# **Awel y Môr Offshore Wind Farm**

## **Applicant's Response to the Examining Authority's Third Written Questions**

### **Deadline 7**

**Date: 08 March 2023**

**FIGURE TITLE:** APPENDIX C - RESPONSE TO ExA3 Q9.8 AGRICULTURAL LAND CLASSIFICATION (ALC) (WALES) SURVEY AND 2023 ALC SURVEY RESULTS

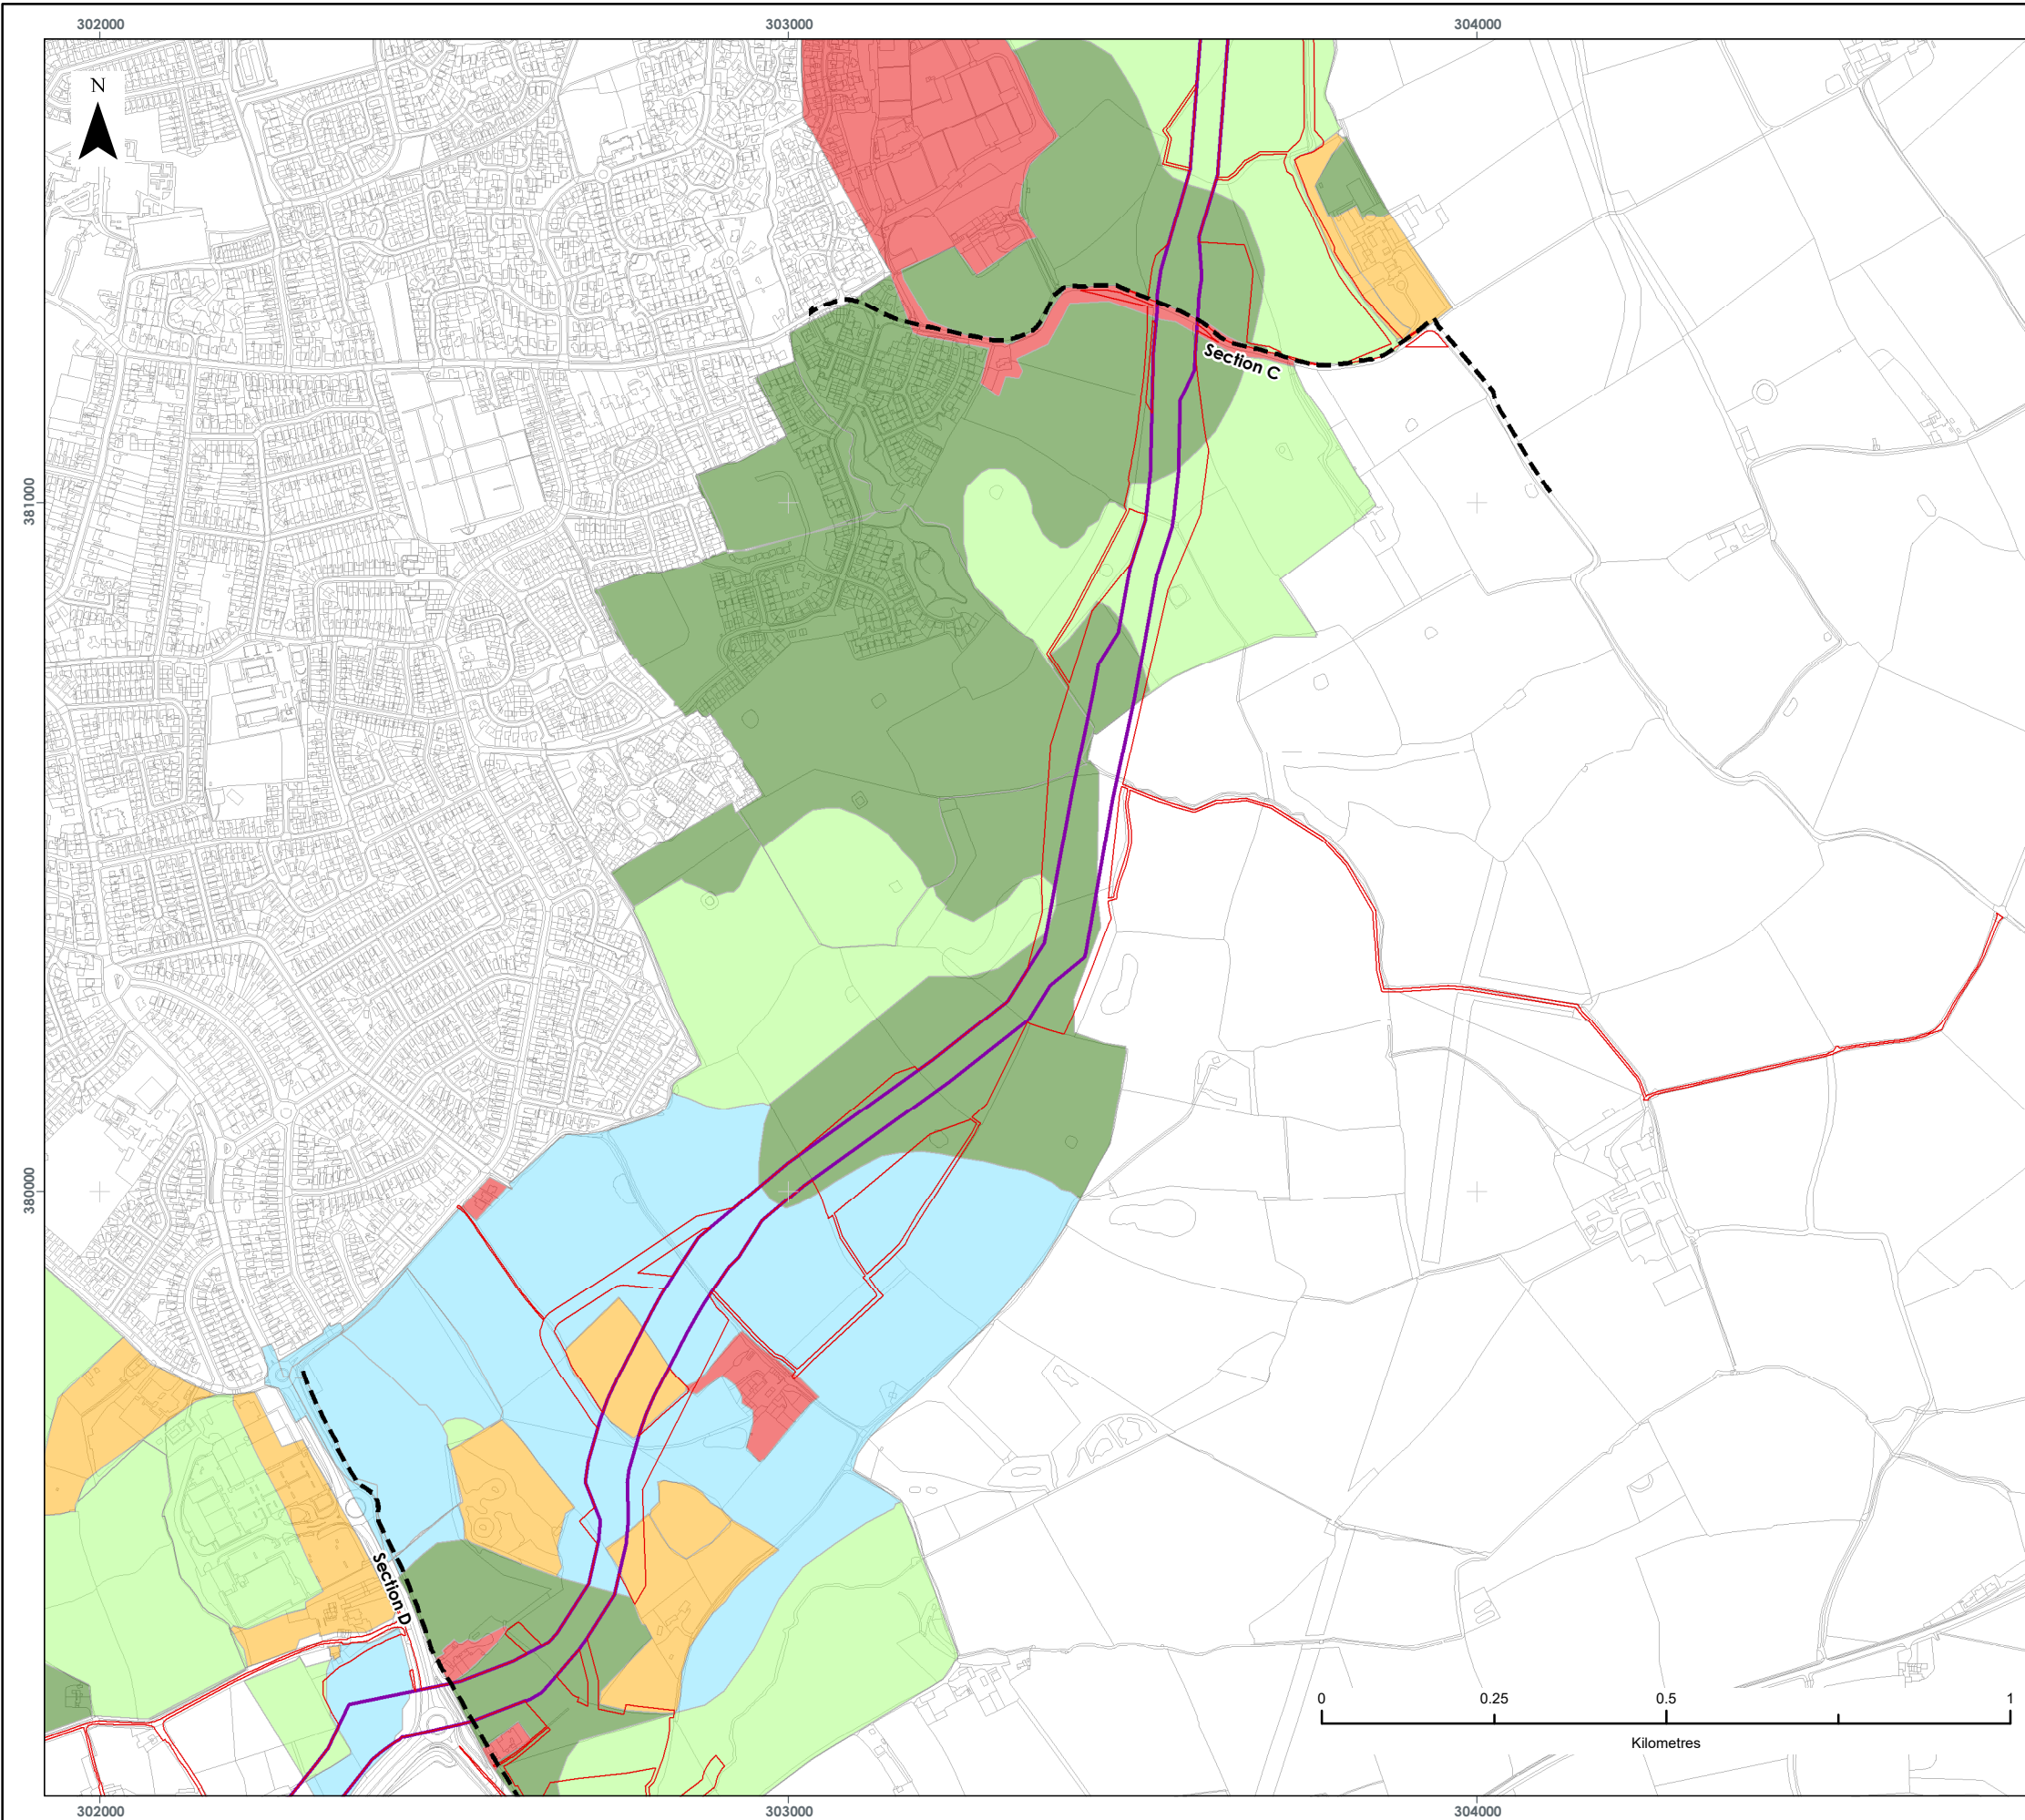
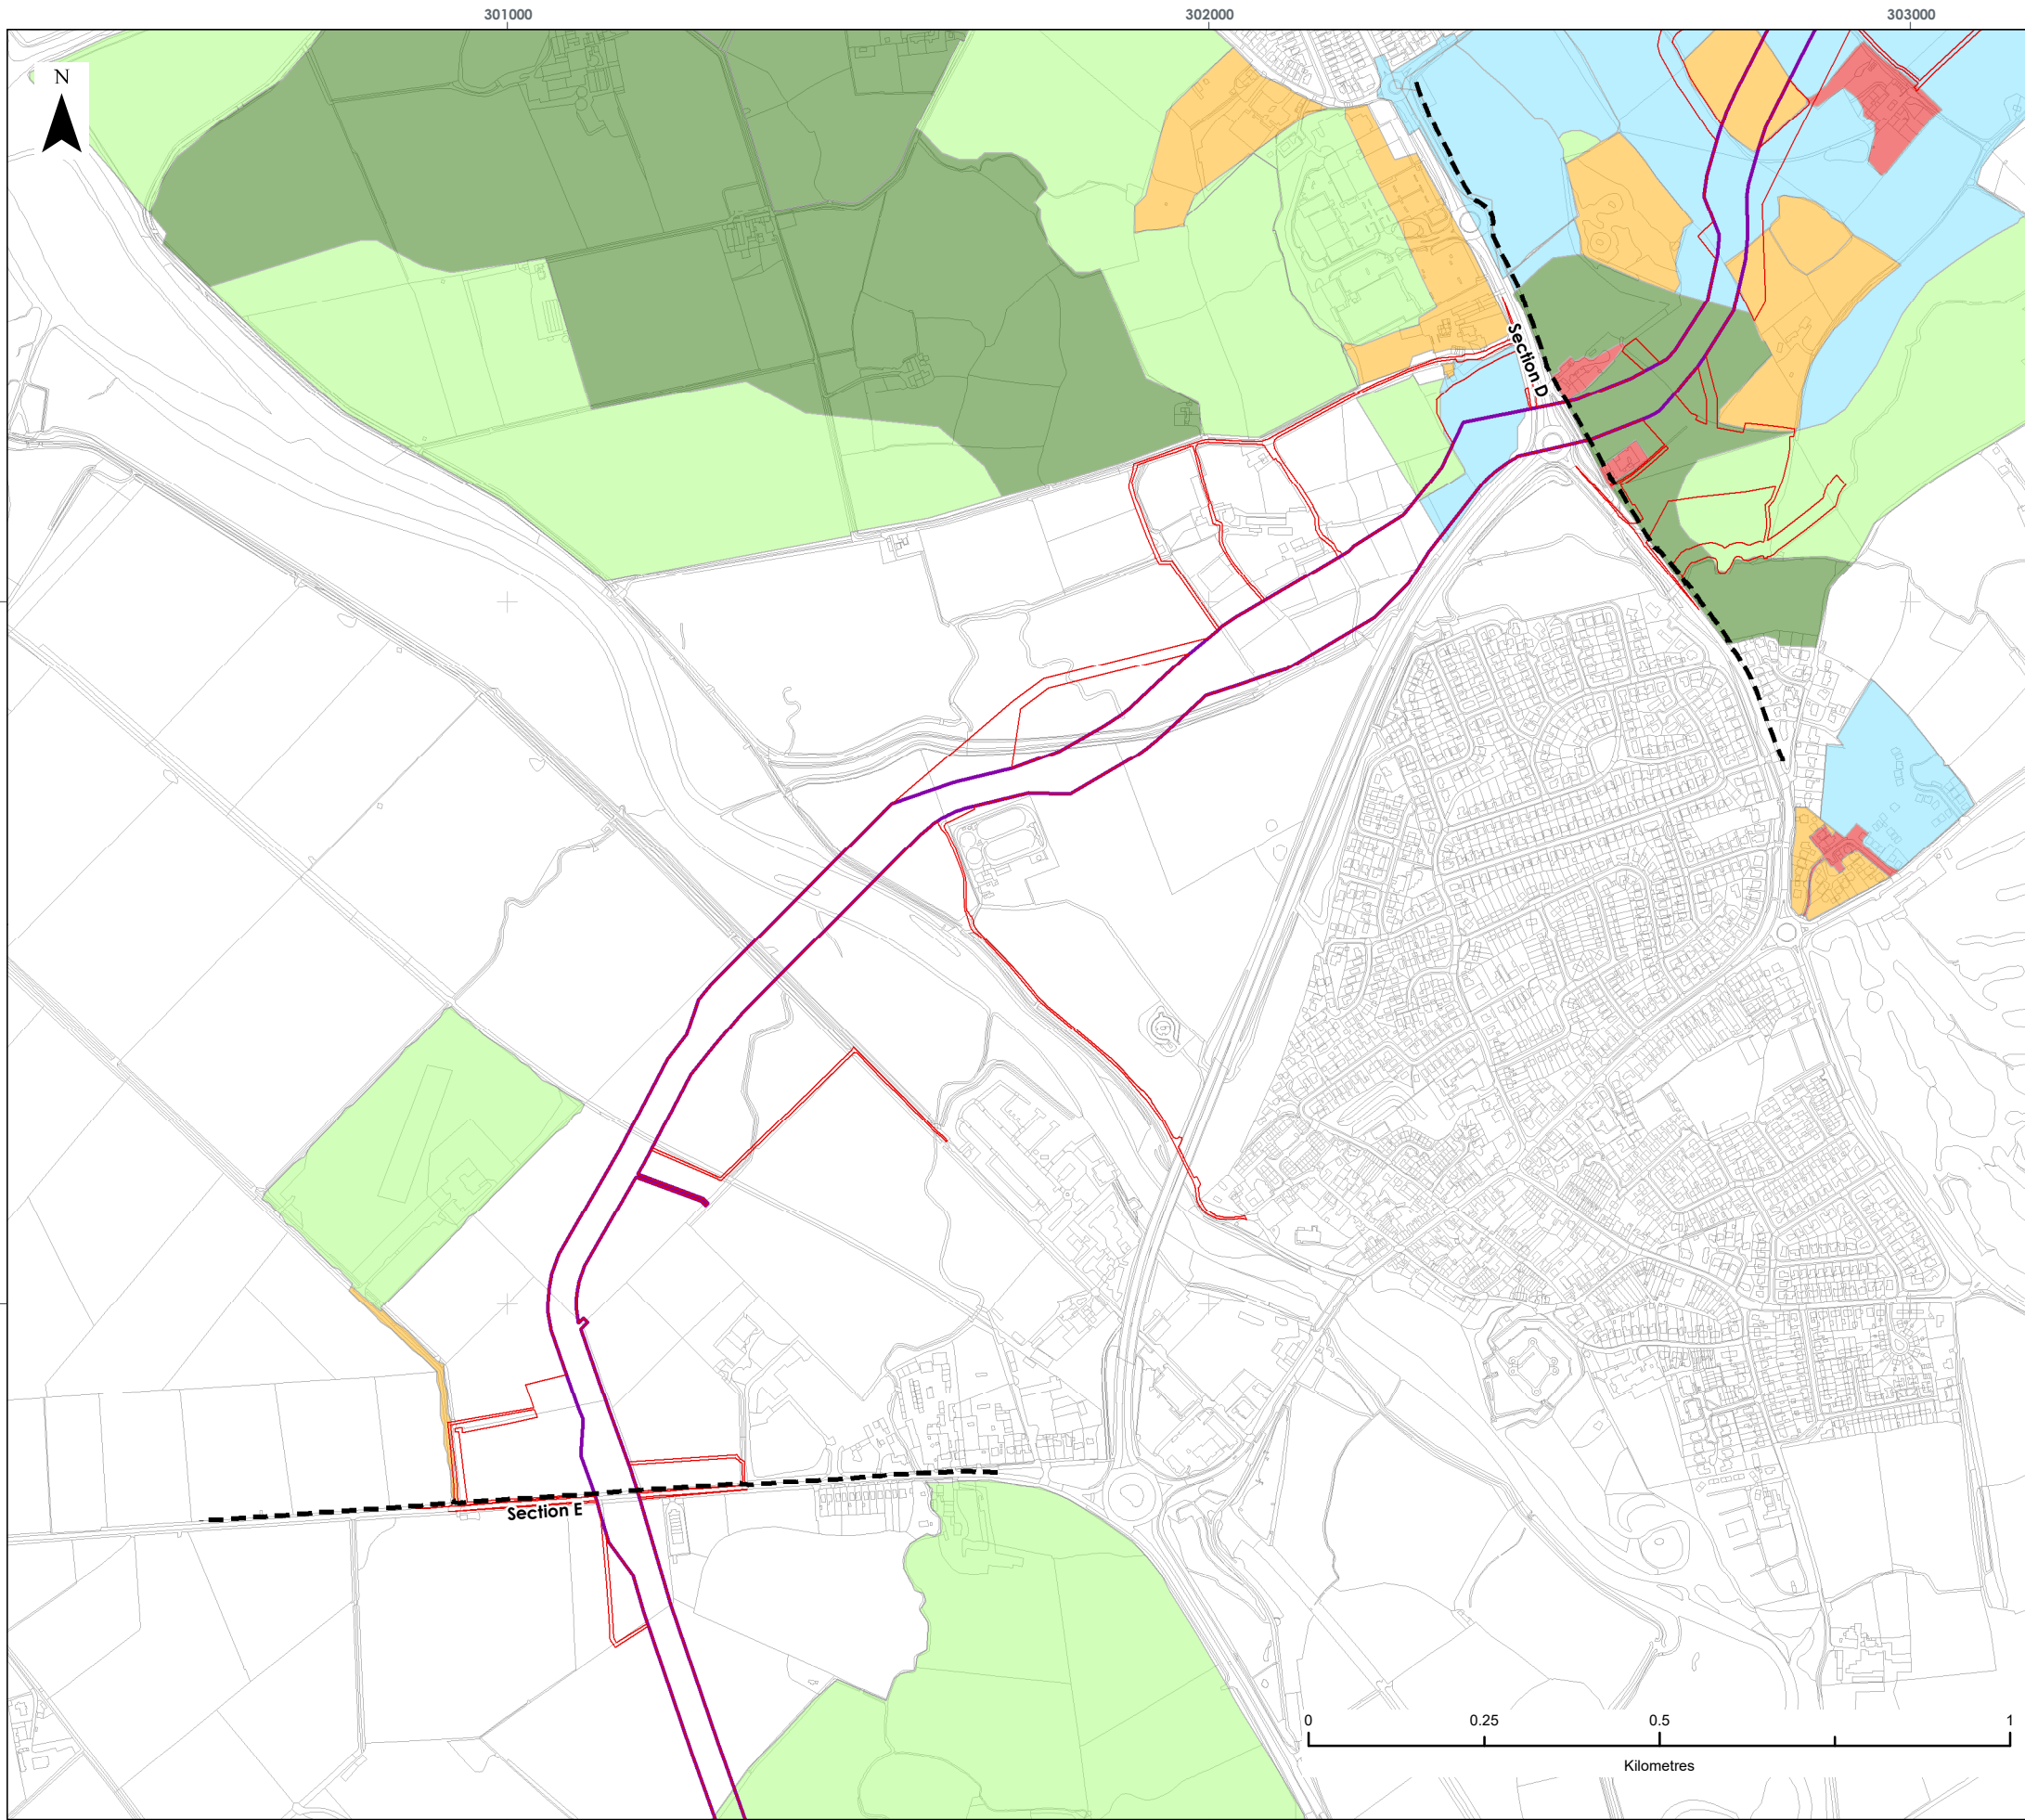
QUESTION NUMBER	QUESTION ADDRESSED TO	QUESTION	APPLICANT'S RESPONSE																											
	Farming Company																													
9.6	Applicant	<p><b>Onshore Substation Site (OnSS)</b></p> <p>Noting that a further Agricultural Land Classification (ALC) survey has been undertaken at the proposed OnSS site, is it necessary to update the table provided in response to ExQ1.9.8 [REP1- 007]?</p>	<p>The Applicant has updated the table to incorporate the results of the 2023 Agricultural Land Classification (ALC) survey as follows:</p> <p>The area of the OnSS footprint and wider landscape mitigation and ecological compensation and enhancement area (Plot 417), includes 1.5 Ha of Grade 3a which represents 0.69% of Grade 3a within 1000m of OnSS and 0.011% of Grade 3a land in Denbighshire.</p>
